**PLANNED UNIT DEVELOPMENT
& SUBDIVISION STAFF REPORT****Date: July 16, 2020****DEVELOPMENT NAME**

Atchison Place Subdivision

Planned Unit Development Approval to allow multiple
buildings on a single building site, and Subdivision
approval to create one legal lot of record.

SITE PLAN

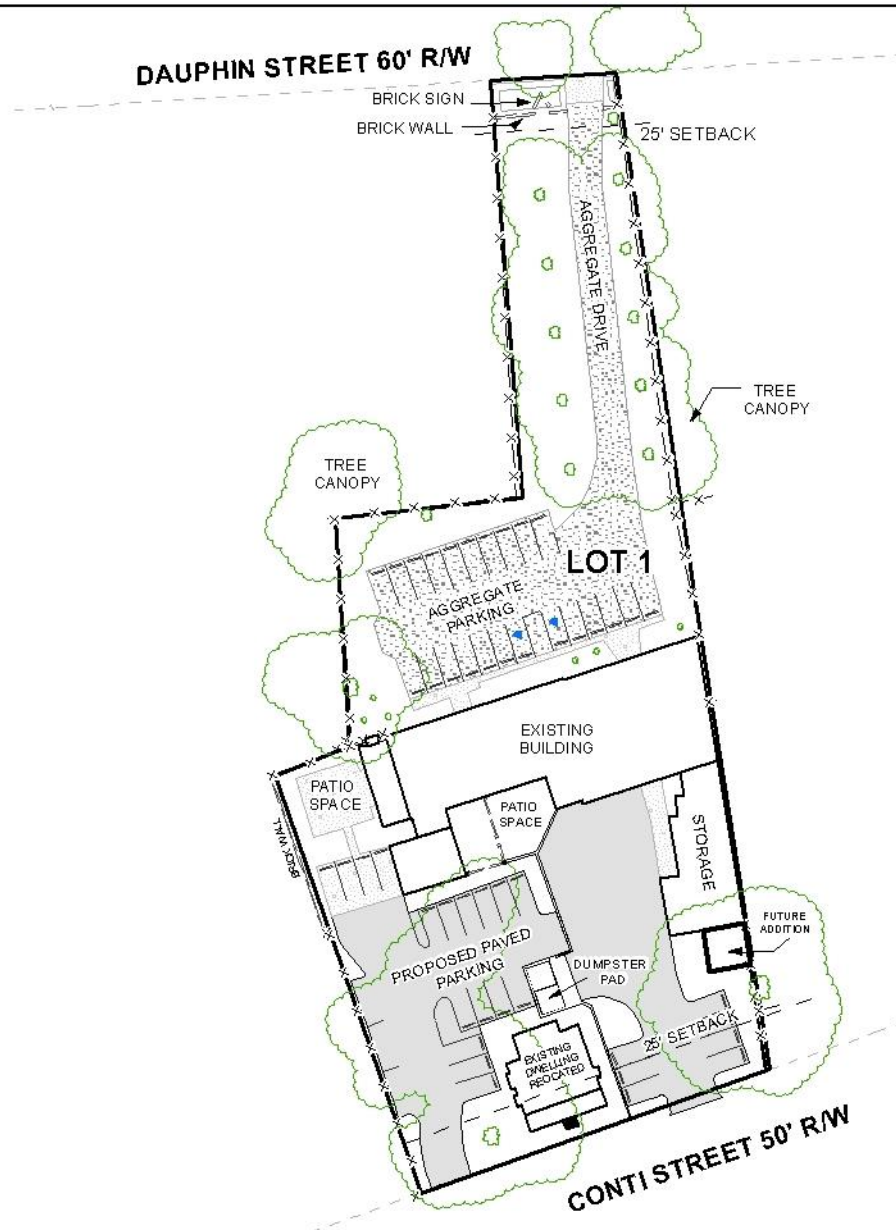
- 1. Add a TITLE to this sheet "PUD SITE PLAN".
- 2. Label the existing and proposed items, including curb cuts, or provide a legend.
- 3. Revise NOTE #1. Add "PERMITTING" so that the note reads "Any work performed in the existing ROW (right-of-way) such as driveways, sidewalks, utility connections, grading, drainage, irrigation, or landscaping will require a ROW permit from the City of Mobile Engineering Permitting Department (208-6070) and must comply with the City of Mobile Right-of-Way Construction and Administration Ordinance (Mobile City Code, Chapter 57, Article VIII).

- 4. ADD THE FOLLOWING NOTE TO THE PUD SITE PLAN:
 - a. Any existing or proposed detention facility shall be maintained as it was constructed and approved. The Land Disturbance Permit application for any proposed construction includes a requirement of a Maintenance and Inspection Plan (signed and notarized by the Owner) for the detention facility. This Plan shall run with the land and be recorded in the County Probate Office prior to the Engineering Department issuing their approval for a Final Certificate of Occupancy.

- 5. Retain NOTES #2 - #5, as shown on the unlabeled application drawing dated 06-15-2020.

Regarding the Subdivision aspect of the request, the lot meets the minimum size and frontage requirements. The lot size in both square feet and acres is labeled on the preliminary plat, and this should be retained on the Final Plat, or a table should be furnished on the Final Plat providing the same information. The PUD does not have a lot size label, but it does contain the lot size in the Site Data, and this should be retained on the site plan.

The 25' minimum building setback lines do not appear to be labeled or identified on the preliminary plat, but are labeled on the site plan. Therefore, the plat should be revised to depict the 25' minimum building setback lines along Dauphin Street and Conti Street, and the lines should be retained on the site plan.

As proposed, the site plan depicts an aggregate surfacing and maneuvering area on the North side of the site to remain. Requests to allow the existing aggregate surfacing to remain as well as substandard parking lot lighting were heard at the March 2018 Board of Zoning Adjustment meeting. The Parking Lot Lighting request was approved by the Board, but the other requests were withdrawn by the applicant at that meeting. The applicant has submitted a request to allow the aggregate parking on the North side of the main building to remain, and is scheduled to be heard at the August 3rd Board of Zoning Adjustment meeting. Should the request be denied, the site plan should be revised to provide compliant paved surface parking in this area.

The site plan depicts a dumpster pad with truck access/maneuvering area. A note should be required on the PUD site plan stating that dumpsters will be in compliance with Section 64-4.D.9. of the Zoning Ordinance.

- 1) retention of the 25' minimum building setback line along all street frontages;
- 2) retention of the right-of-way widths for Dauphin Street and Conti Street;
- 3) placement of a note on the site plan stating that the dumpster pad and enclosure must be in compliance with Section 64-4.D.9. of the Zoning Ordinance;
- 4) retention of the lot size in both square feet and acres;
- 5) placement of a note on the site plan stating tree and landscape compliance will be maintained at existing levels;

6. revision of the site plan to provide compliant parking surfaces in all areas of the site should the request for the aggregate surfacing be denied by the Board of Zoning Adjustment;

- 6) compliance with the Engineering comments: *(1. Add a TITLE to this sheet "PUD SITE PLAN". 2. Label the existing and proposed items, including curb cuts, or provide a legend. 3. Revise NOTE #1. Add "PERMITTING" so that the note reads "Any work performed in the existing ROW (right-of-way) such as driveways, sidewalks, utility connections, grading, drainage, irrigation, or landscaping will require a ROW permit from the City of Mobile Engineering Permitting Department (208-6070) and must comply with the City of Mobile Right-of-Way Construction and Administration Ordinance (Mobile City Code, Chapter 57, Article VIII). 4. ADD THE FOLLOWING NOTE TO THE PUD SITE PLAN: a. Any existing or proposed detention facility shall be maintained as it was constructed and approved. The Land Disturbance Permit application for any proposed construction includes a requirement of a Maintenance and Inspection Plan (signed and notarized by the Owner) for the detention facility. This Plan shall run with the land and be recorded in the County Probate Office prior to the Engineering Department issuing their approval for a Final Certificate of Occupancy. 5. Retain NOTES #2 - #5, as shown on the unlabeled application drawing dated 06-15-2020.);*
